# APPENDIX A

## MODEL REVIEW

# A1 DARLINGTON POINT FLOOD STUDY MODEL REVIEW

**Plate A1** XP-RAFTS Model sub-catchment delineation for the ‘Murrumbidgee River at Darlington Point and Environs Flood Study’ (2018)

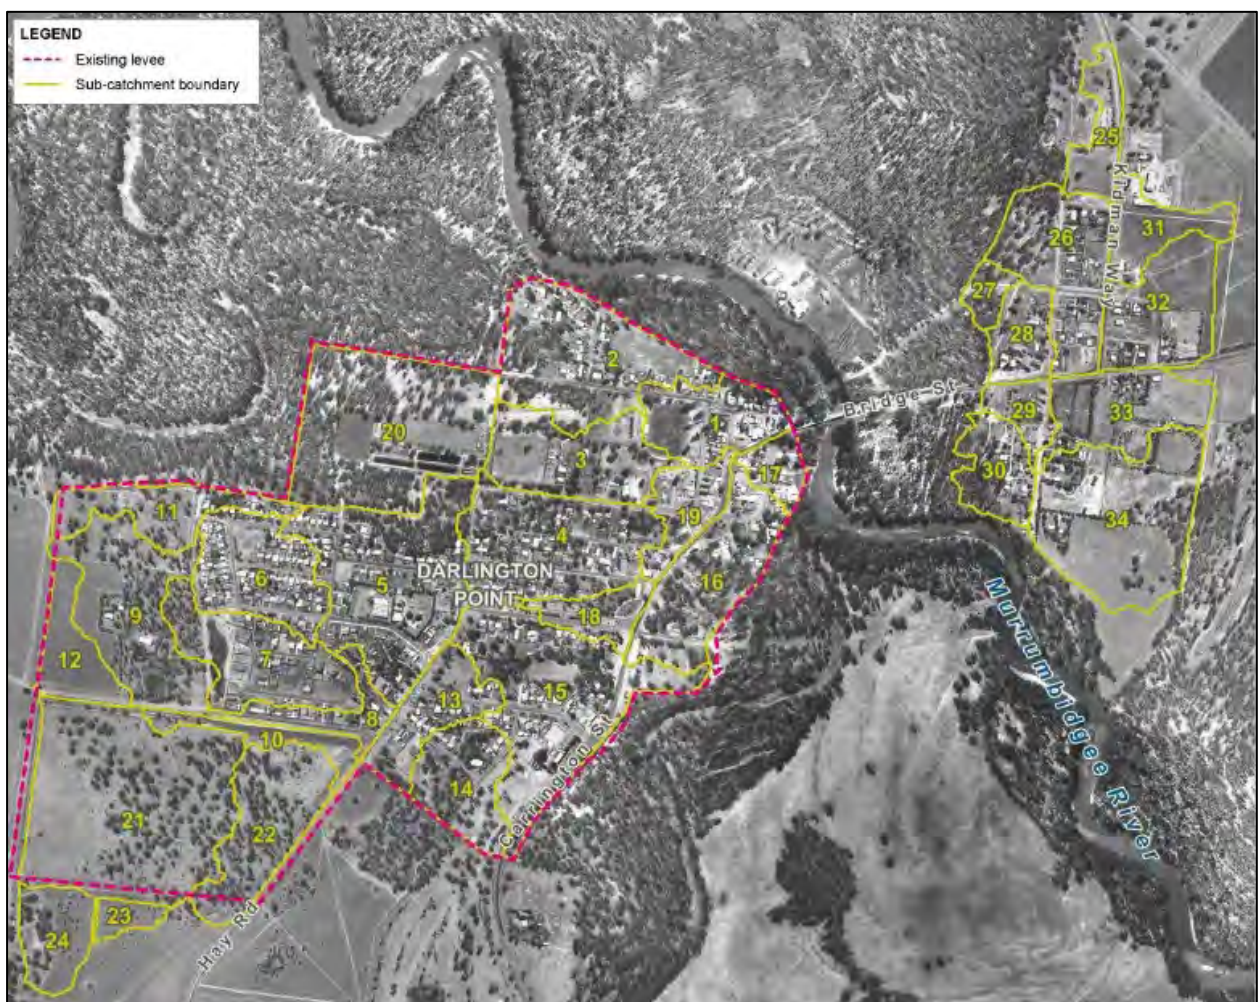
The XP-RAFTS model comprises 23 local sub-catchments at Darlington Point and 10 sub-catchments at North Darlington Point, as shown in **Plate A1**. No discussion is included in the

flood study regarding how subcatchment boundaries were delineated. However, the subcatchment boundaries were compared to ground surface elevations within the 1m x 1m gridded DEM derived from NSW LPI LiDAR survey. On this basis, the alignment of the subcatchment boundaries appear to be reasonably defined.

Only the 19 hydrological sub-catchments located within the existing levee extent were applied to the TUFLOW model. However, the additional sub-catchments were incorporated into the hydrological model to enable future assessments of the potential levee extension at Darlington Point and a levee construction at North Darlington Point.

The report also documents that it was assumed that around 25% of each sub-catchment was comprised of impervious surfaces (roads, roofs etc.) based on analysis of a sample of aerial photography of the town. Therefore, an impervious sub-area equal to 25% of the total subcatchment area was applied to subcatchments 1 to 19 that are located within the levee and comprise a reasonable degree of urbanisation. It is recommended that these values be reviewed

and specific values for the pervious/impervious subareas within each sub-catchment be applied in order to provide the best description of hydrologic processes across the sub-catchments within the levee.

It was also noted that a pervious “n” (PERN) value of 0.06 was adopted for pervious sections of each subcatchment, while a PERN value of 0.025 was adopted for impervious sections of each subcatchment. As impervious surfaces (e.g., roads, concrete) will have a lower roughness relative to pervious sections of the catchment (e.g., grass, shrubs, trees), the use of different PERN values is appropriate. However, it is suggested that the PERN values could be modified to better reflect the different resistance to flow afforded by the pervious/impervious areas. The XP-RAFTS User Manual suggests a PERN value of 0.015 for impervious sub-areas. For pervious areas, it is recommended that a weighted average PERN value be calculated for each sub-catchment based on the constituent land uses/material types within each area. Therefore, it is recommended that the PERN values used in the model be reviewed and revised, as appropriate.
